Supplemental material for Tgd comments

*Itzik Kitroser
Yossi Segal
Yigal Leiba
Zion Hadad
Runcom Technologies Ltd.*

This contribution provides specific text changes instructions as a supplemental text for 802.16-REVd sponsor ballot. Editorial instruction is indicated by a **red bold** text with square brackets. Deletions are indicated by a ~~strikethrough~~ text and new text insertion is indicated by an underline.

Figure 211—Example of mapping FEC blocks to OFDMA slots to subchannels and symbols in the downlink (in PUSC mode)

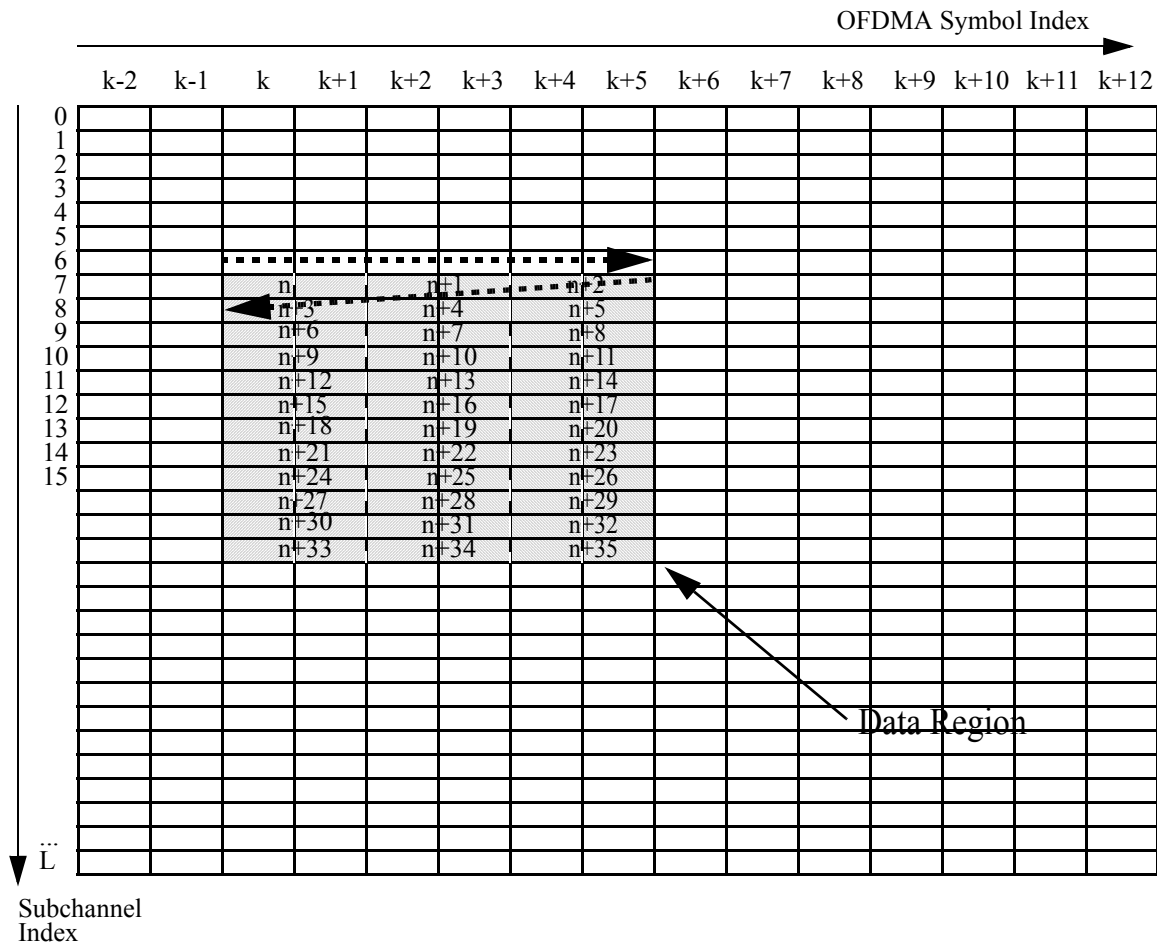
Comment #257. The current OFDMA PHY contain usage of concepts as Zone and a Segment which are not clearly defined anywhere. A clear definition of the terms is required for a consistency reasons. In addition the OFDMA data mapping referes to FEC block, while the correct term is OFDMA slot.

- 1) Segment the data into blocks sized to fit into one ~~FEC block~~OFDMA slot.
- 2) Each ~~FEC block~~ slot shall span one or more subchannels in the subchannel axis and two or three OFDMA symbol in the time axis (see ~~Figure 210 and Figure 211~~). Map the ~~FEC blocks~~ slots such that the lowest numbered ~~FEC block~~ slot occupies the lowest numbered subchannel in the lowest numbered OFDMA symbol.
- 3) Continue the mapping such that the OFDMA symbol index is increased. When the edge of the Data Region is reached, continue the mapping from the lowest numbered OFDMA symbol in the next sub-channel.

Figure 213—Time plan - one TDD time frame (with only mandatory zone)

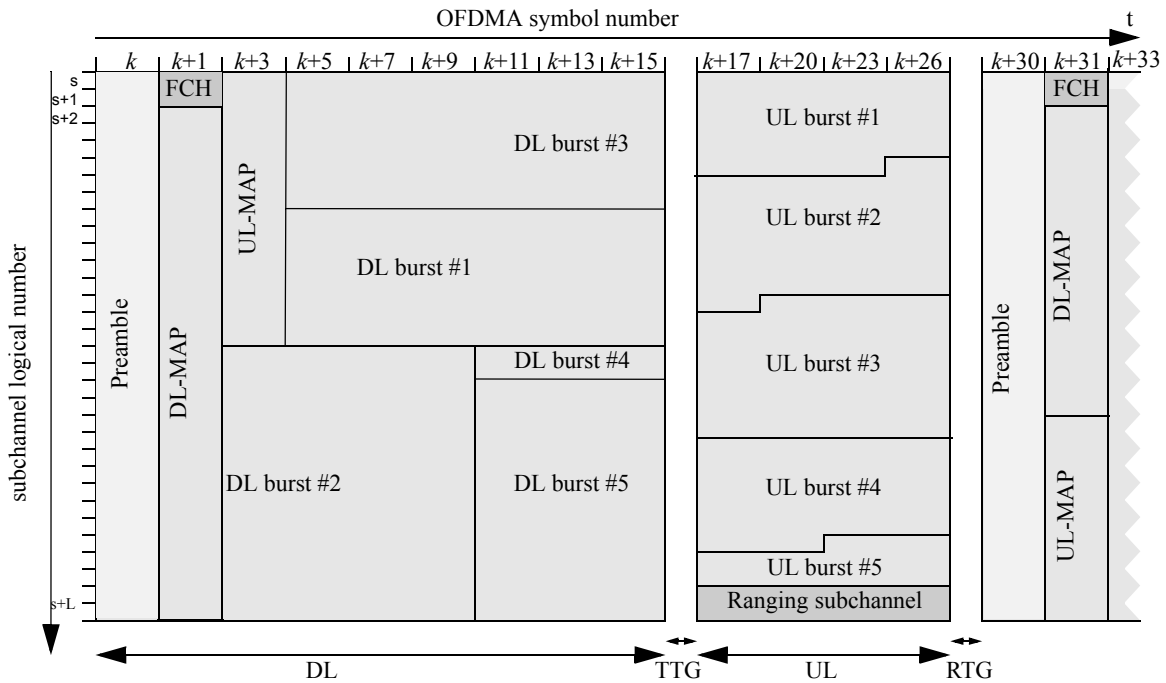
Comment #350 changed the UL allocating scheme to a uni-dimensional scheme. This means that the UL allocations are no longer rectangles, this should be reflected in figure 213. In addition figure 213 does not provide a clear example of the OFDMA frame with multiple zones.

[Page 468, line 5, section 8.4.4.2, change figure 213 (and title) as follows:]

Figure 215—FCH subchannel allocation for all 3 segments

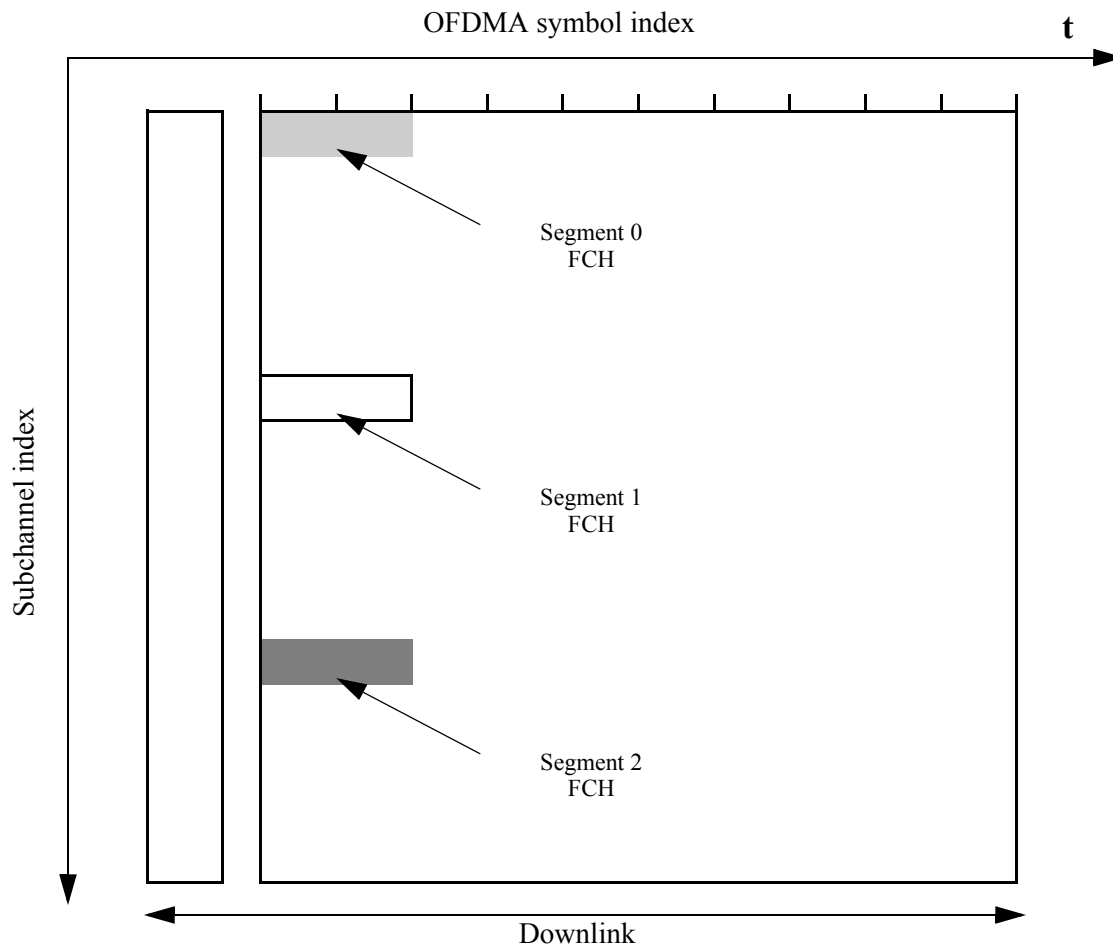
In addition, figure 215 describes the FCH as transmitted over one OFDMA symbol and two subchannels, and should be two OFDMA symbols over one subchannel.

[Page 471, line 4, section 8.4.4.5, replace figure 215 with the following figure]

Figure 216—Example of renumbering the allocated subchannels for segment 1 in PUSC

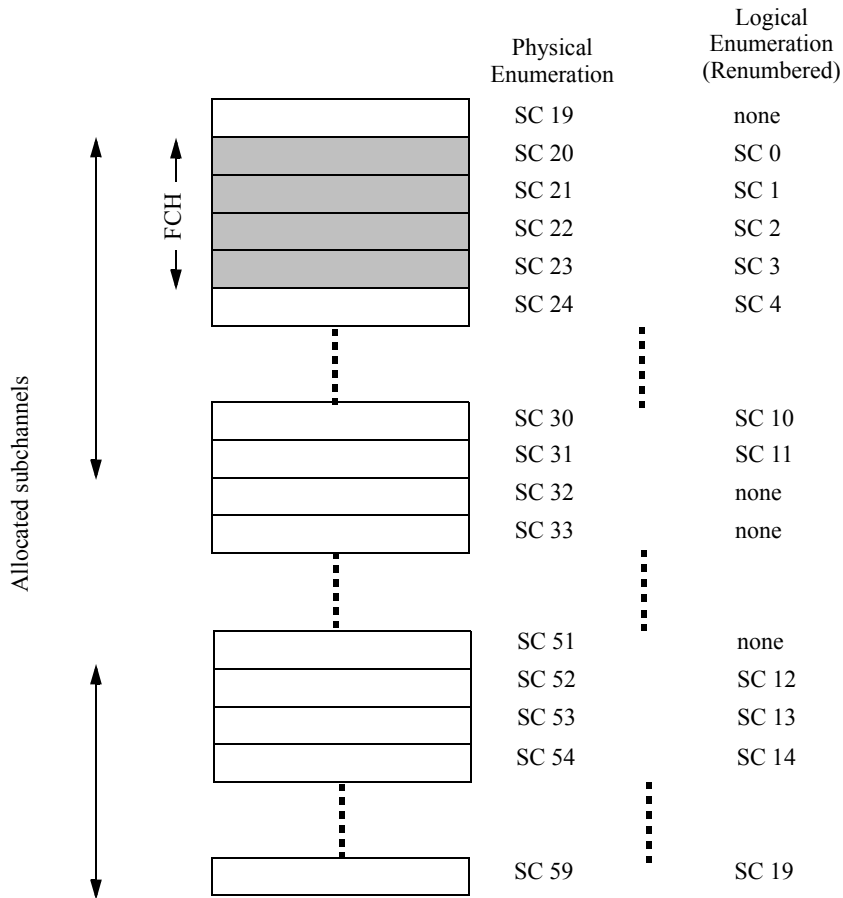
The example given in figure 216 is wrong, since the standard defines that the FCH is transmitted using a duration of 4 OFDMA subchannels.

[Page 472, line 2, section 8.4.4.5, Change figure 216]

Figure 217—Example of UL renumbering the allocated subchannels for a segment in PUSC

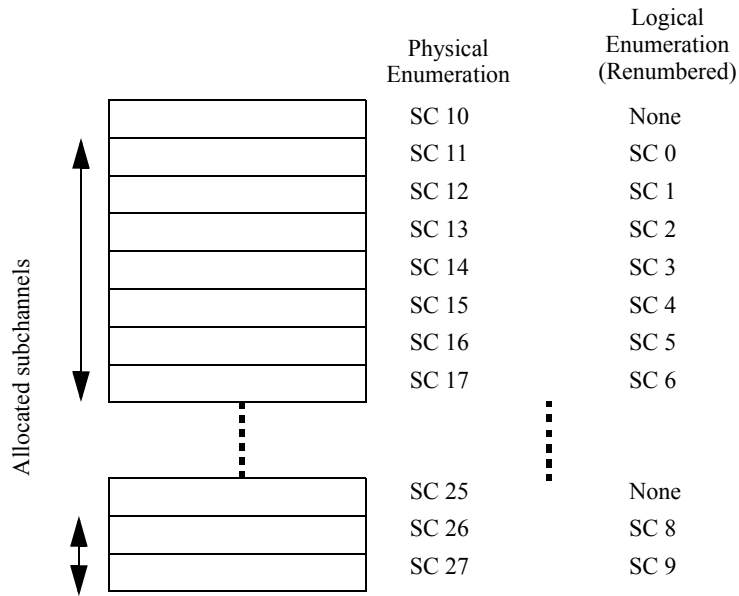
The current subchannels renumbering definition for the UL stating that "no renumeration is done" is wrong, since obviously a renumbering scheme is required.

[Page 472, line 2, section 8.4.4.5, Insert new figure 217]
